From: Ron Lovaglio <rlovaglio@roadrunner.com>
Sent: Thursday, October 09, 2014 7:18 PM
To: Susan Redmond
Subject: Charlie's Subaru Application

I live at 20 Smith Street and the West side of my property abuts the Mr. Shuman's property. This is in reference to the Mr. Shuman's application before the planning board October 14th.

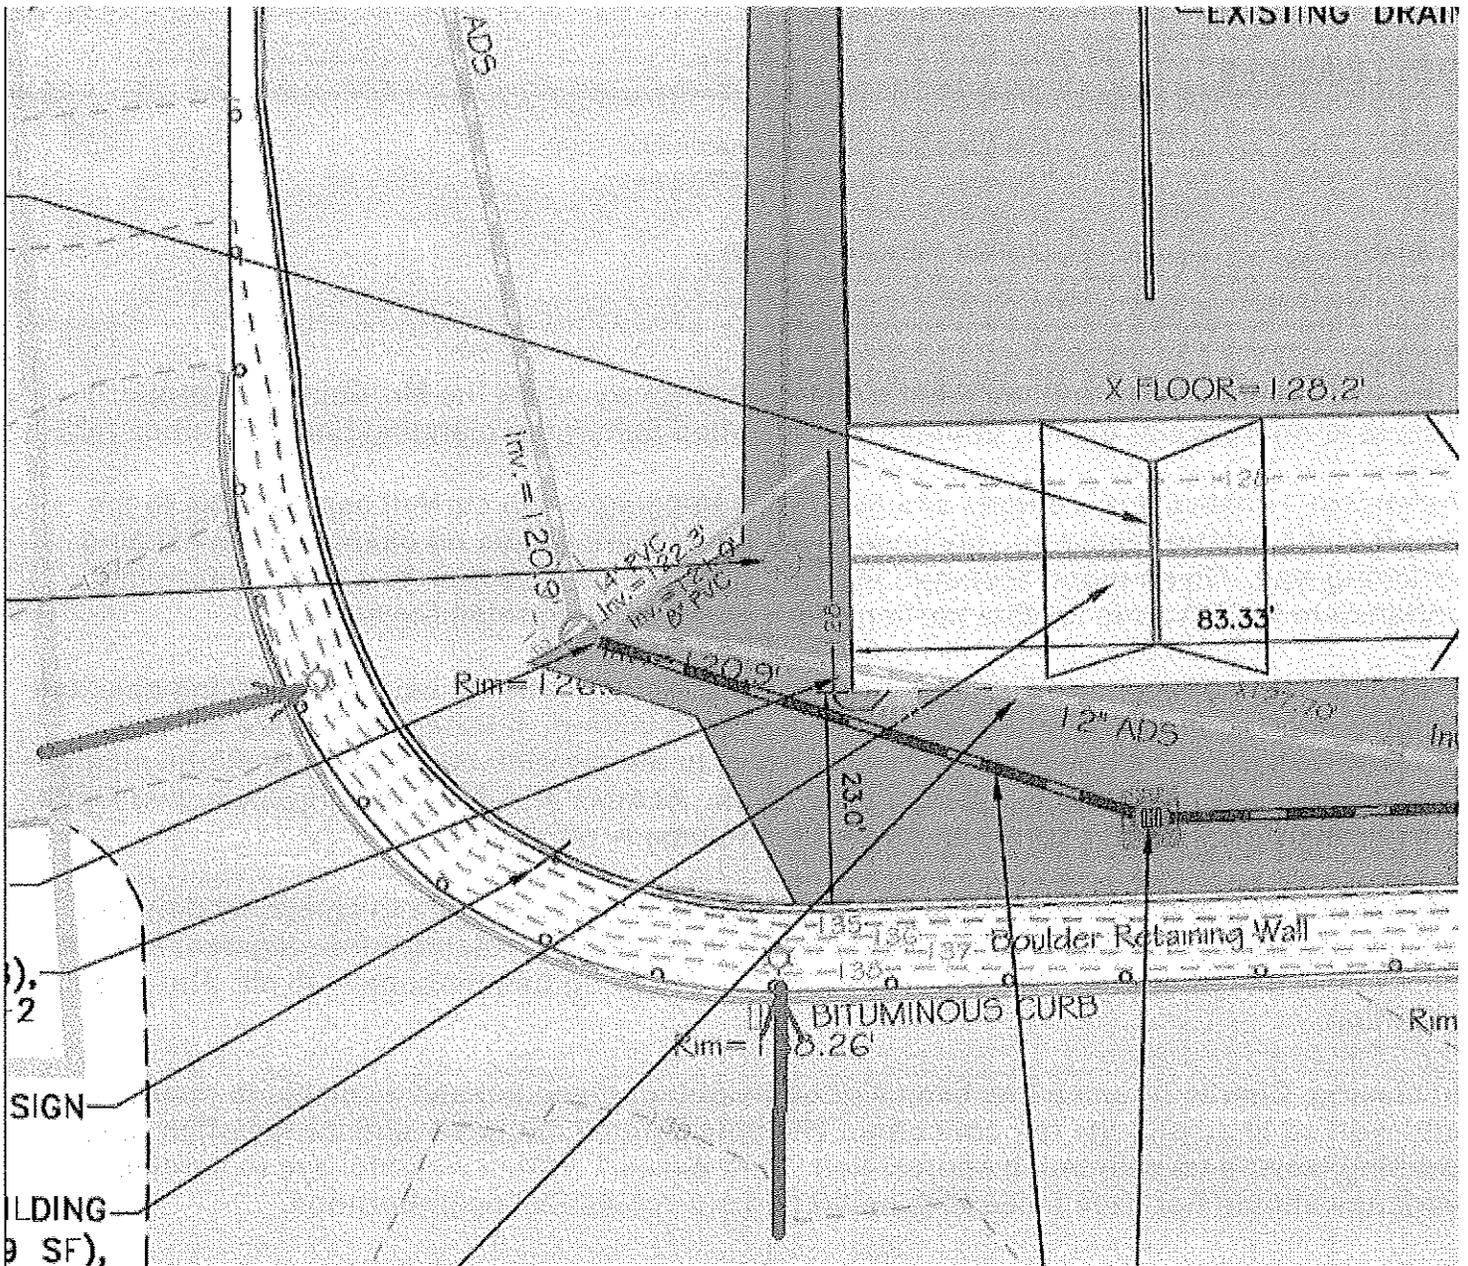
I would like to comment on lighting. Any building addition should have down facing shielded lighting such as is on the south side of the current building. Furthermore, there are two existing bright pole lights, noted with red arrows in the drawing below that are slightly higher than my eye when I am seated in my den or deck. At dusk and early evening these two lights are glaringly bright and exacerbated when the foliage is off the trees.

It would be appreciated if they could be turned downward just a little to shield my den and deck from the glare. I believe the closest one could easily be rotated a few degrees; I'm not sure about the other one. I have not had a chance to bring this personally to Mr. Shuman's attention.
